Access Compliance Report

Public Rights-of-Way

Intersection ID: 27200	Main Street: ANNALEXA_LN	Cross Street: BALLANTYNE_COMMONS_PY	Location: NE
ADA ID: AC7F161D59B8	Ramp Type: Perp	Initial Pass/Fail: Fail	Overall Compliance: No
		Severity Score: 12.5

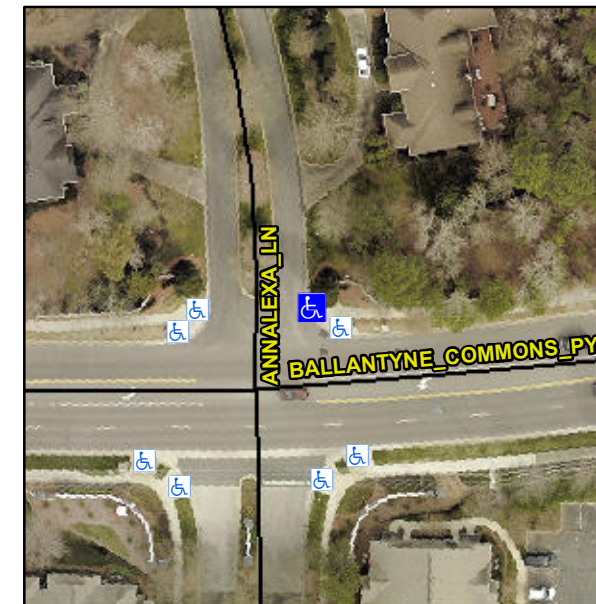
R304.2.2

Compliance	Description	Data	Compliance	Description	Data
N/A	Ramp Length (in)	91.0	No	Ramp Slope (%)	9.3
Yes	Ramp Width (in)	48.0	Yes	Ramp XSlope (%)	1.8
N/A	Flare Type LT	N/A	N/A	Flare Type RT	N/A
N/A	Flare Slope LT (%)	N/A	N/A	Flare Slope RT (%)	N/A
N/A	Flare Traversable LT?	N/A	N/A	Flare Traversable RT?	N/A
N/A	Landing Length (in)	N/A	N/A	DWS Provided?	N/A
N/A	Landing Width (in)	N/A	N/A	DWS Contrast?	N/A
N/A	Landing Slope (%)	N/A	N/A	DWS Length (in)	N/A
N/A	Landing X Slope (%)	N/A	N/A	DWS Full Width?	N/A
N/A	Landing Curb? (Y/N)	N/A	N/A	DWS Offset (in)	N/A
N/A	Shared Landing?	N/A			
N/A	Gutter Ponding?	N/A	N/A	Gutter Slope (%)	N/A
N/A	Gutter Lip Ht (in)	N/A	N/A	Gutter X Slope (%)	N/A
N/A	Painted X Walk1?	No	N/A	Painted X Walk2?	N/A
	X Walk 1 Direction	To NW		X Walk 2 Direction	N/A
N/A	X Walk 1 Width (in)	N/A	N/A	X Walk 2 Width (in)	N/A
	X Walk 1 Slope (%)	5.0		X Walk 2 Slope (%)	N/A
	X Walk 1 X Slope (%)	1.3		X Walk 2 X Slope (%)	N/A

Remove & Replace Entire Ramp.
